PROJECT NAME: BARRE CITY
 PROJECT NUMBER: FECC F 026-(K34) C/2
 FILE NAME: z85b010bdr_if_C2
 PROJECT LEADER: G. BAKOS
 DESIGNED BY: D. PECK
 STREET LIGHTING PLAN #5

PLOT DATE: 3/9/2011
 DRAWN BY: D. PECK
 CHECKED BY:
 SHEET 83 OF 339

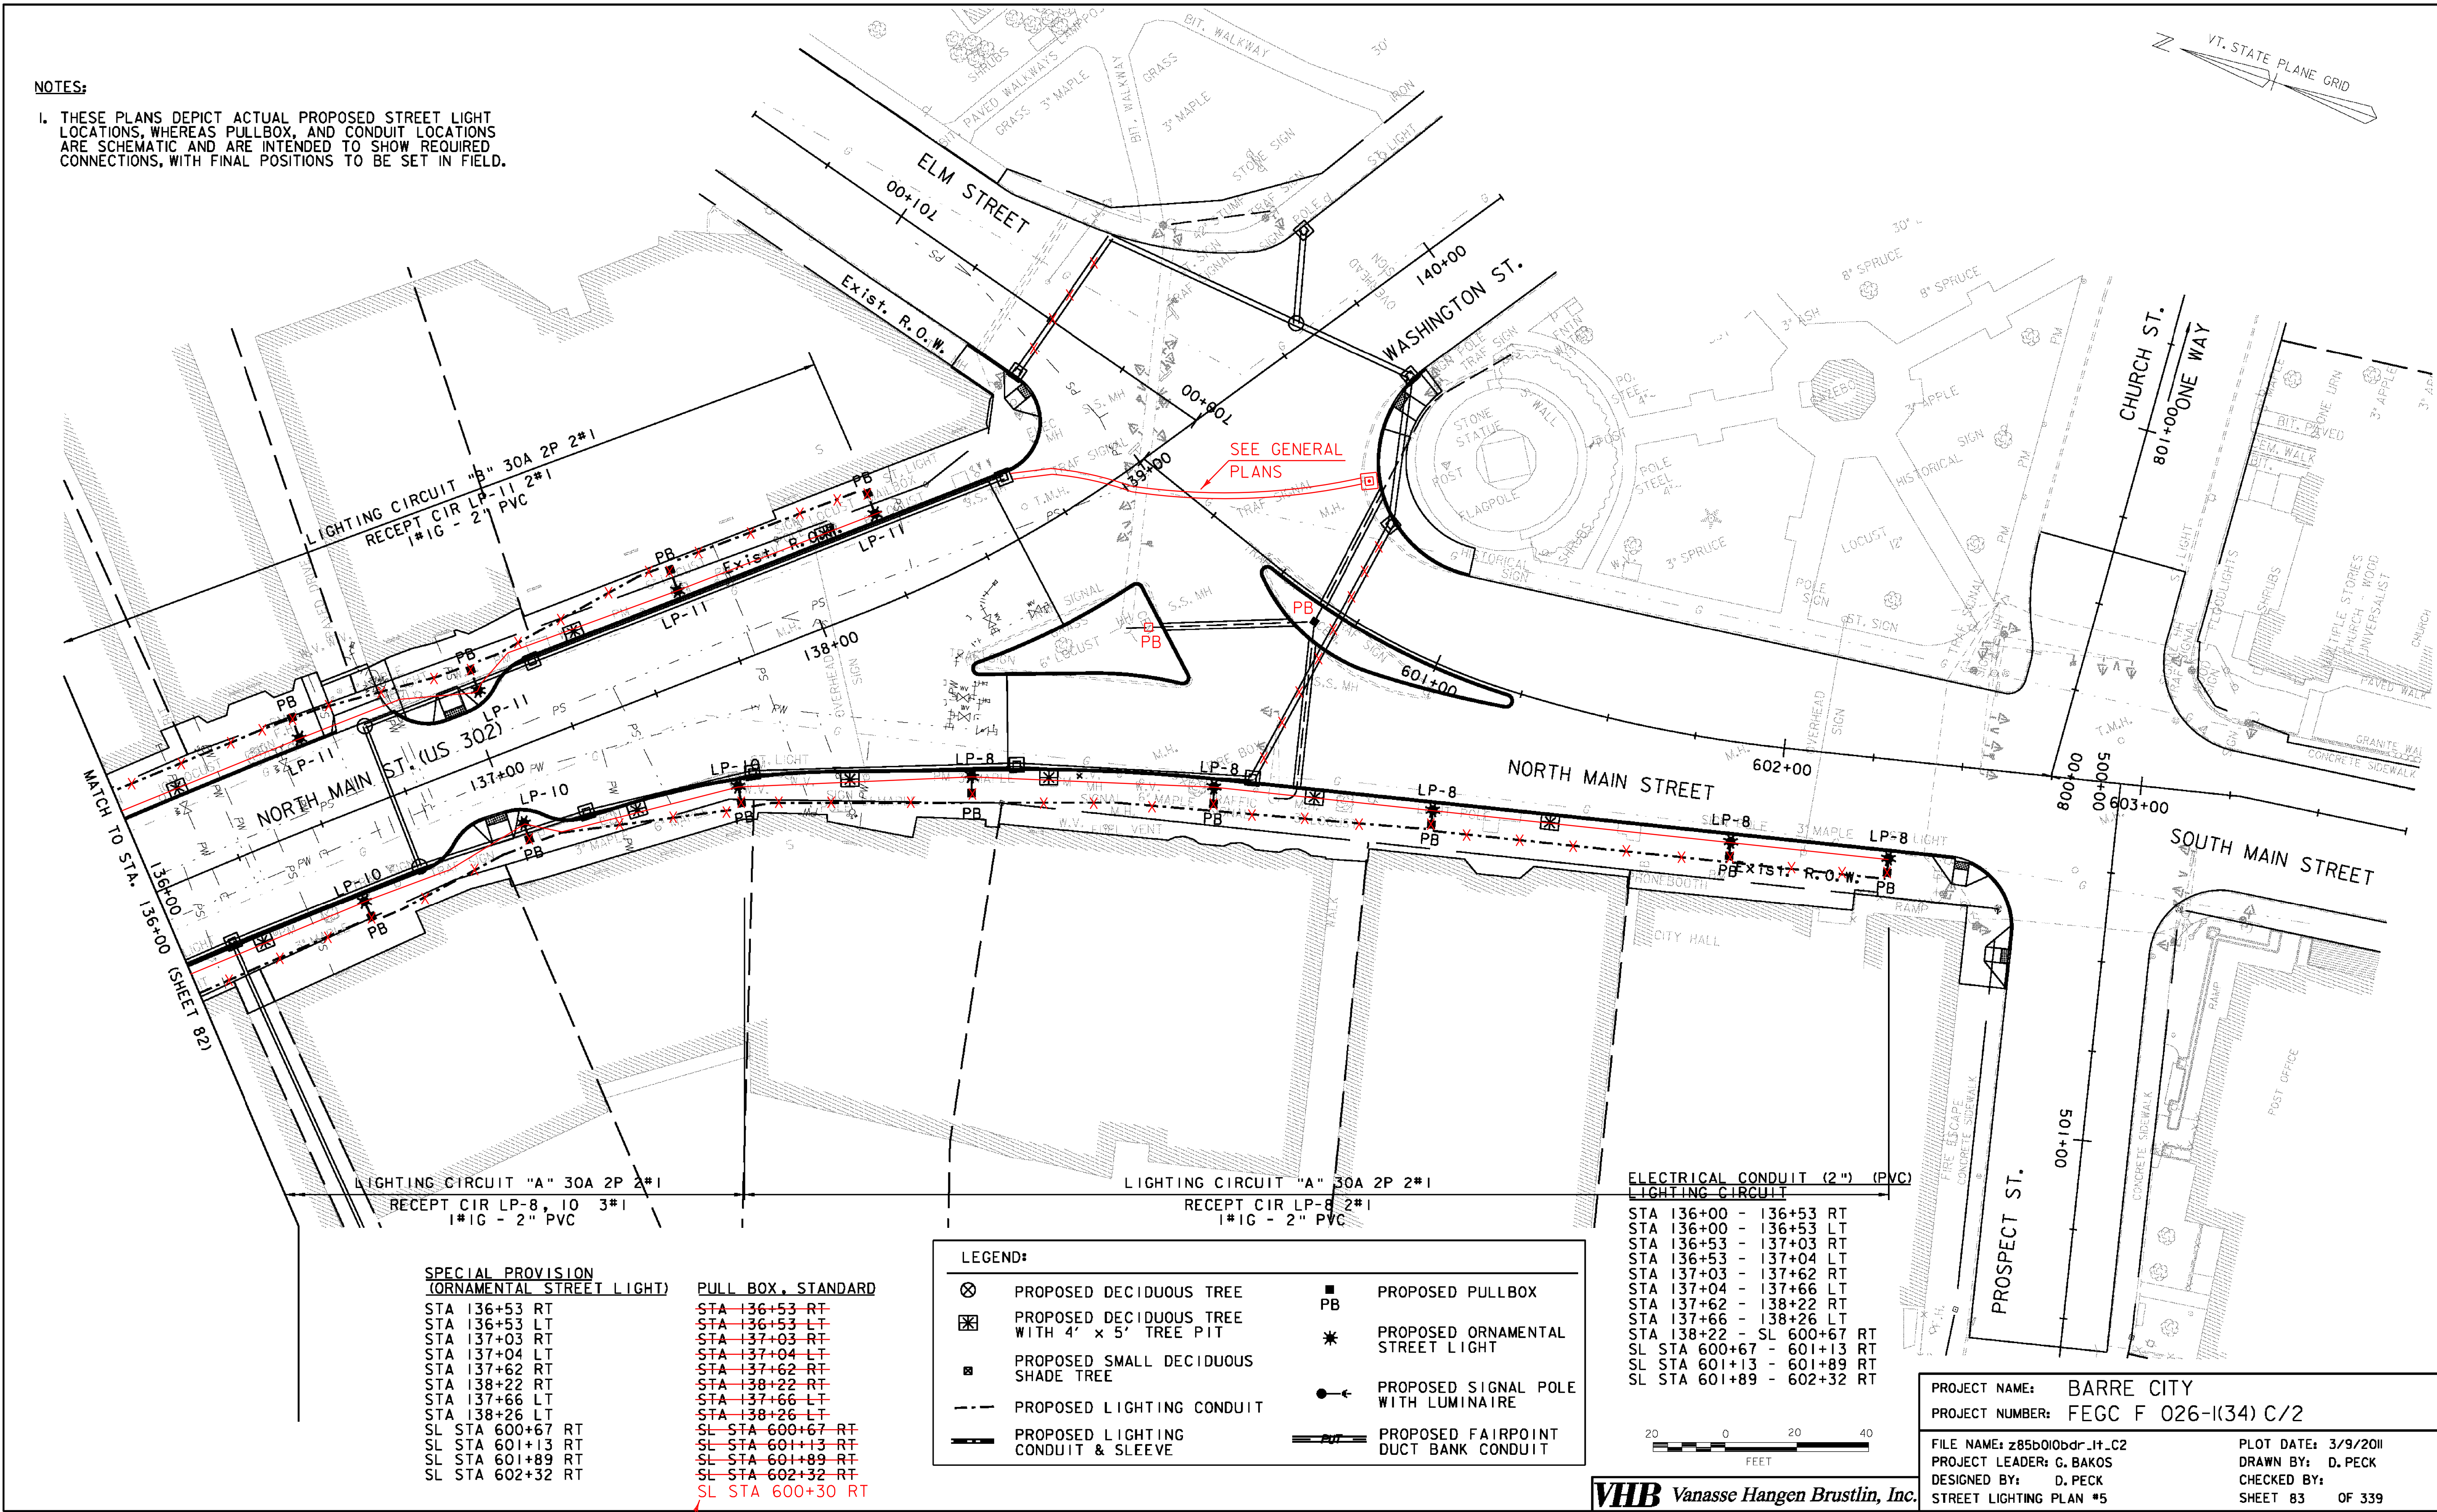
← THIS ONE WAS INSTALLED
